# MOUNT CARDRONA STATION SPECIAL ZONE

**Note:** **Red** text (in **addition** and **deletion**) denotes changes suggested by the QLDC in 2012 as part of preparation for the District Plan review, and agreed to by Mount Cardrona Station Limited

**NOTE: Operative versions of Structure Plans A – D have been deleted. Proposed versions have been inserted as follows**

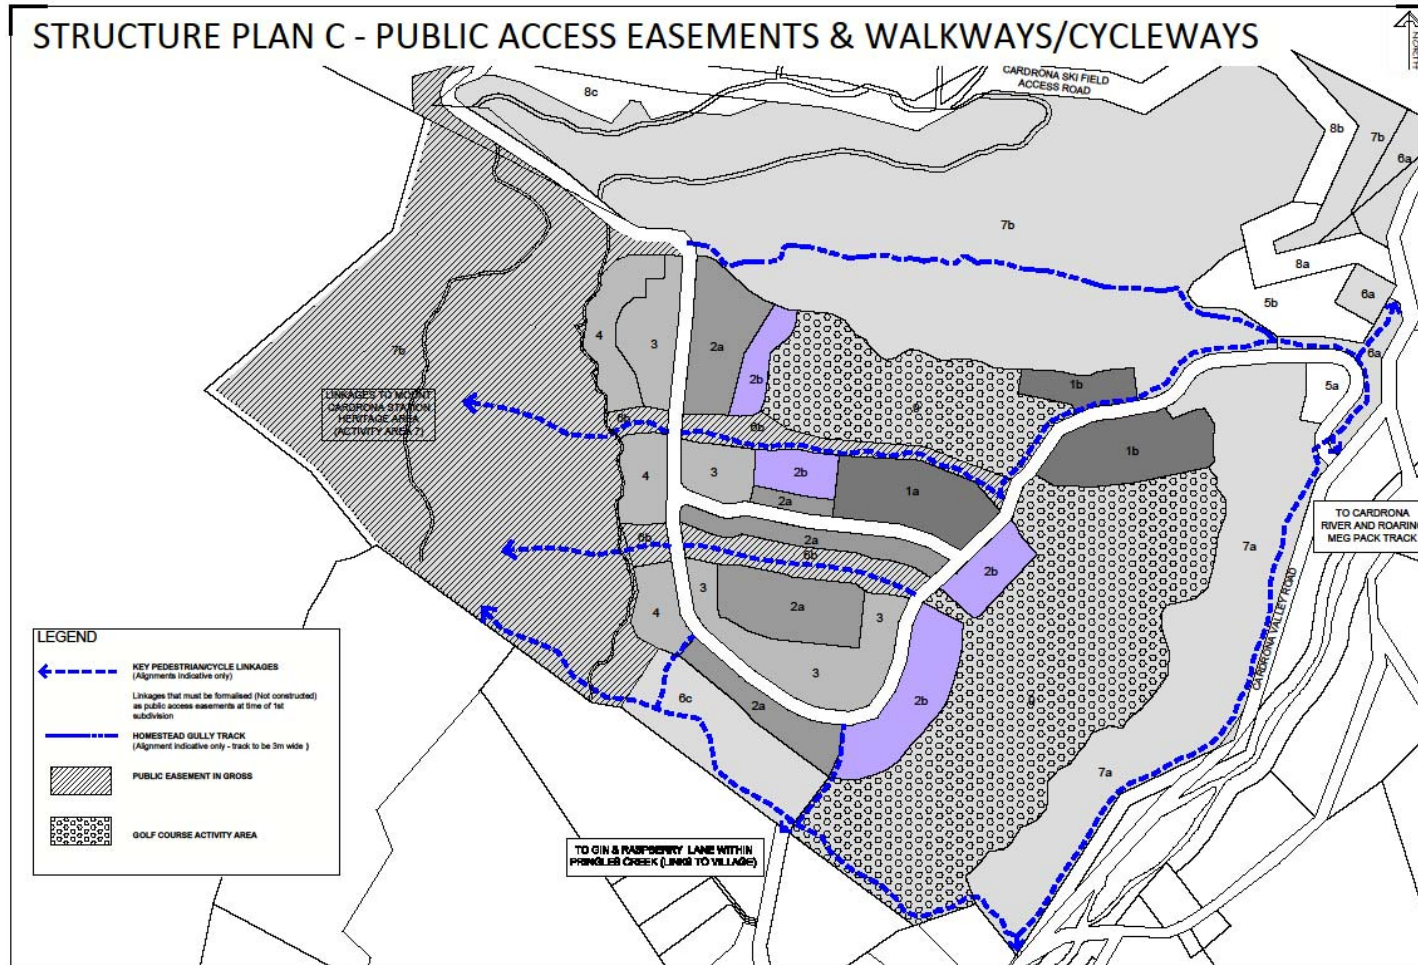
**Comment [DCL15]:** I have just picked up that this plan has removed the public easement in gross from AA6c. There is no assessment of this as far I can see in either the Requestor's s32 or the s42A report. I am not sure about the background to this. It could potentially limit access from Pringles Creek Road.
